**JOHNSON FORK, BAUGESS DRIVE, FLORIDA
STREET WATER BOOSTER STATION Project**

Addendum Number 1

Issued: November 01, 2024

**ADDENDUM NO. 1
CONTRACT 712-21-01
JOHNSON FORK, BAUGESS DRIVE, FLORIDA STREET WATER BOOSTER STATION
DESIGN - CONTRACT 1
CITY OF ASHLAND
ASHLAND, KENTUCKY**

FLORIDA STREET ENLARGED SITE PLAN

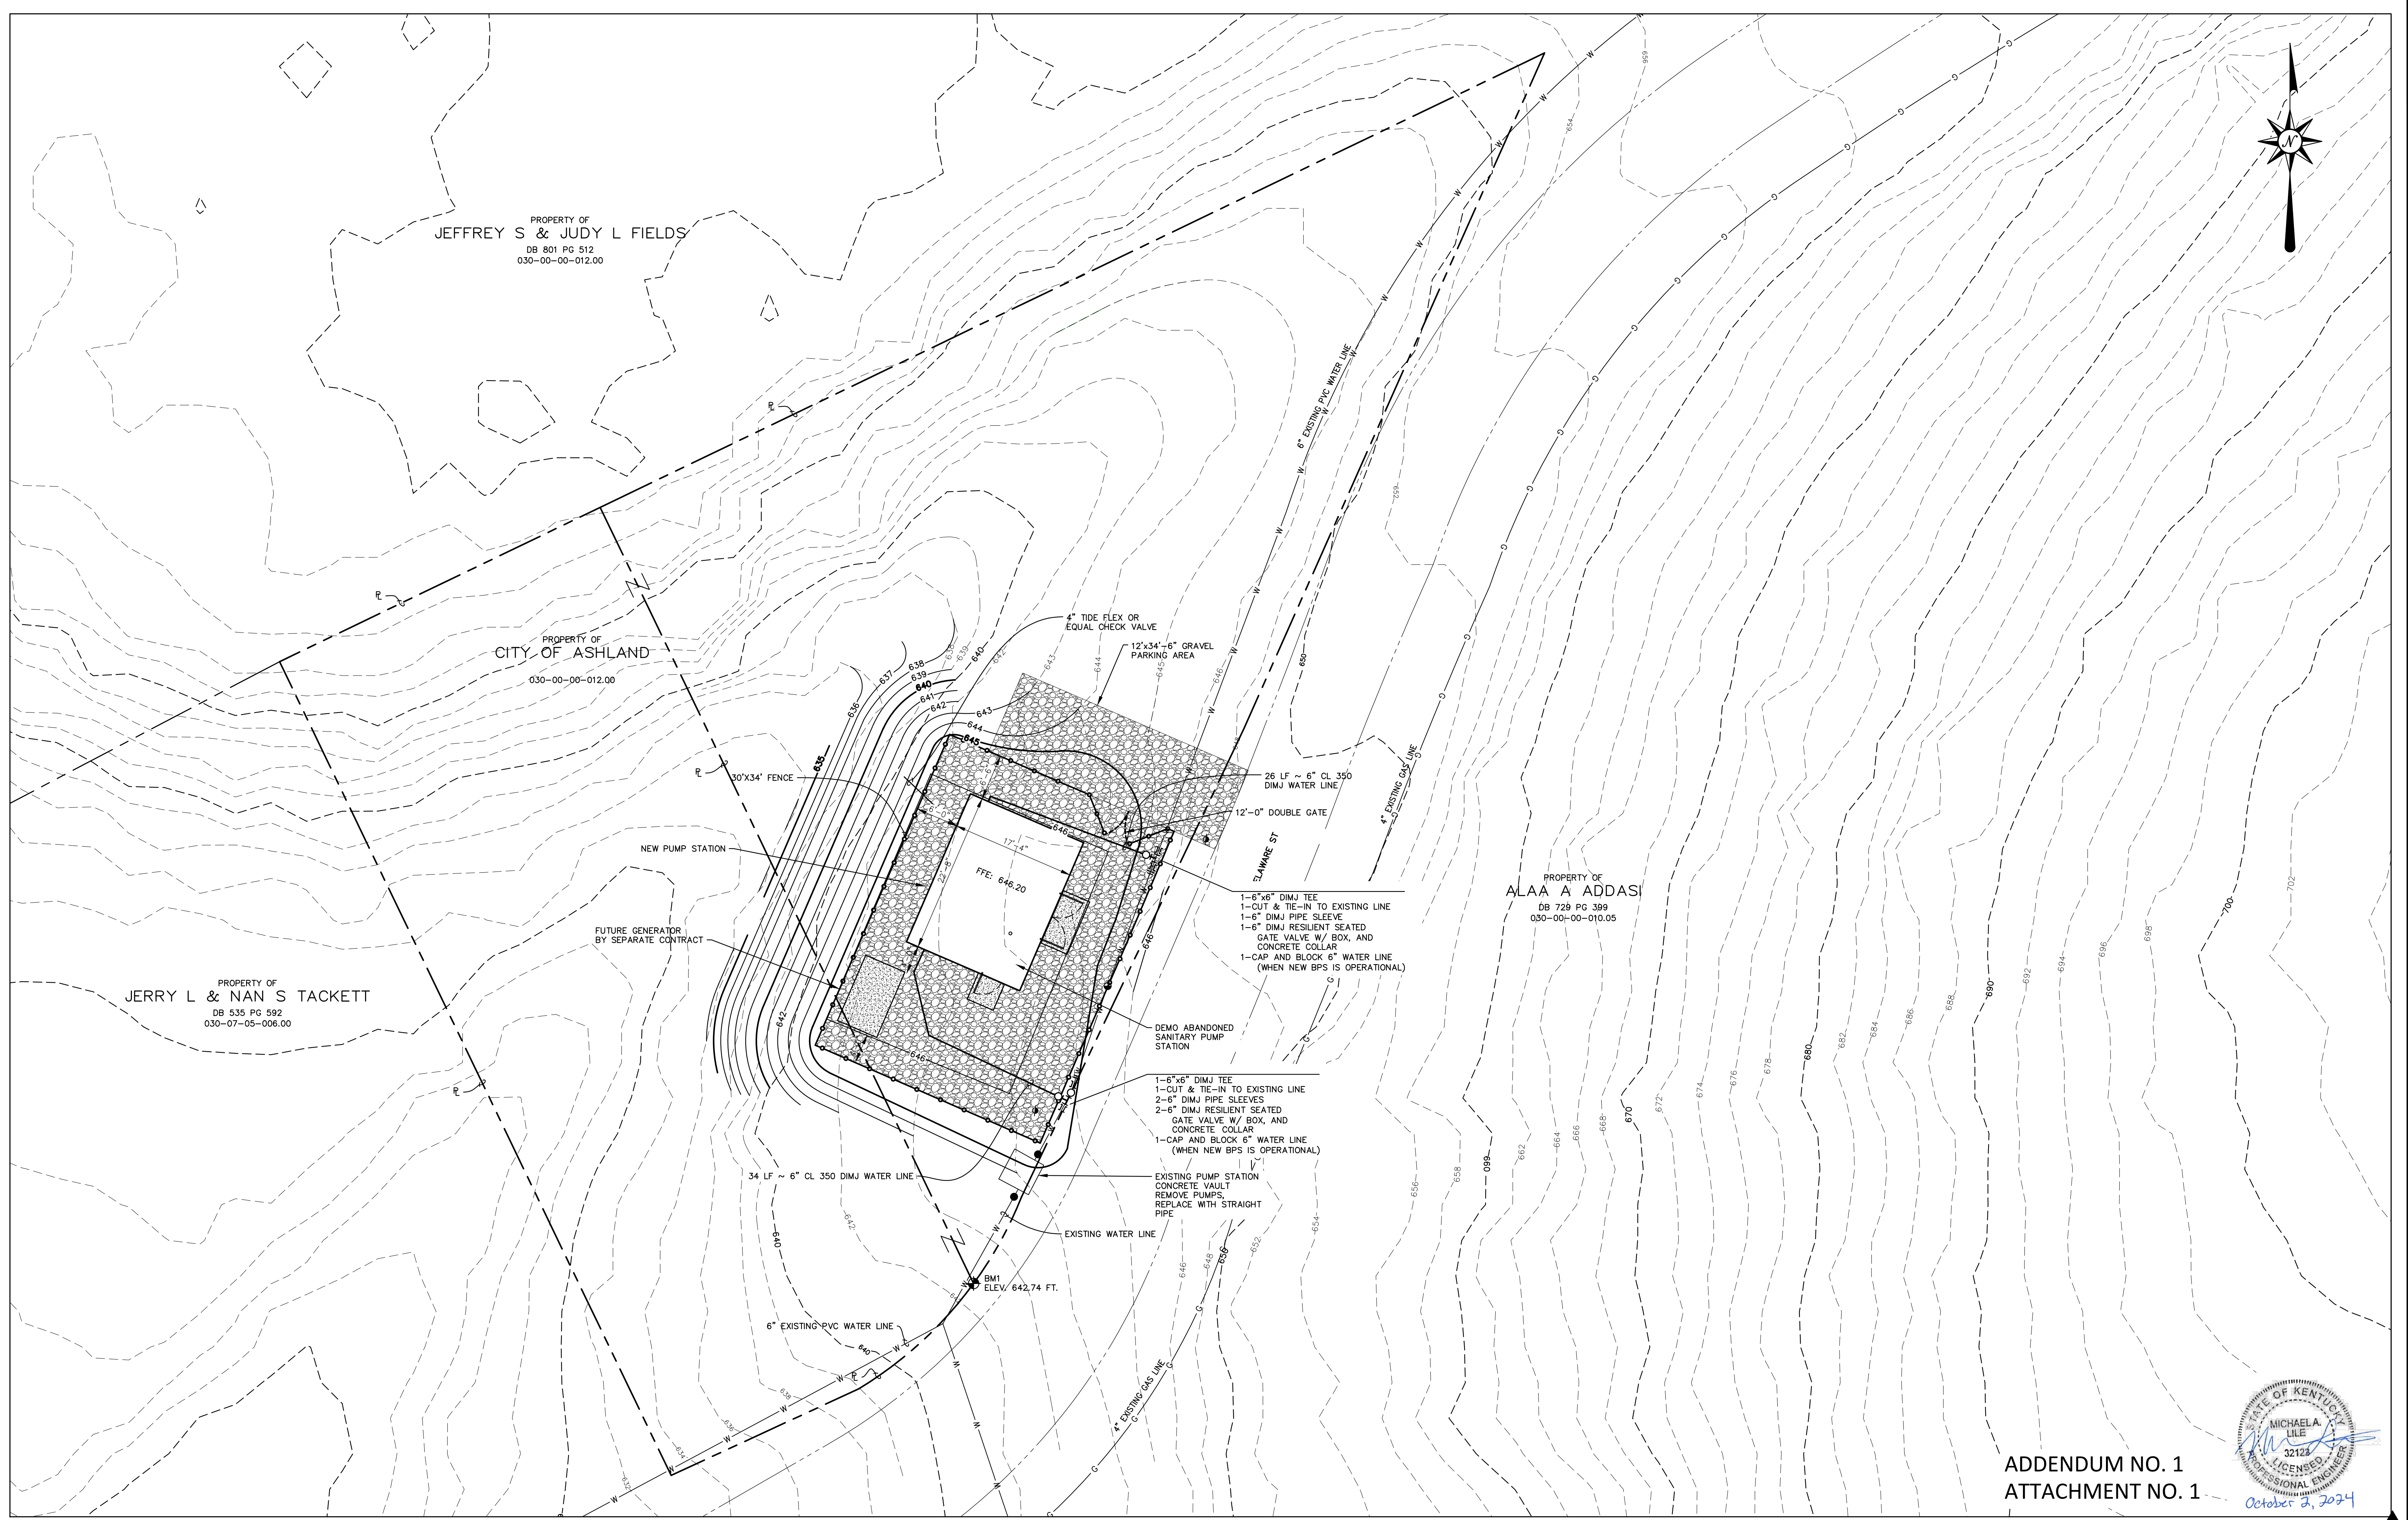
1. Drawing Sheet 03 - FLORIDA STREET ENLARGED SITE PLAN

- a. Replace this sheet with Attachment No. 1
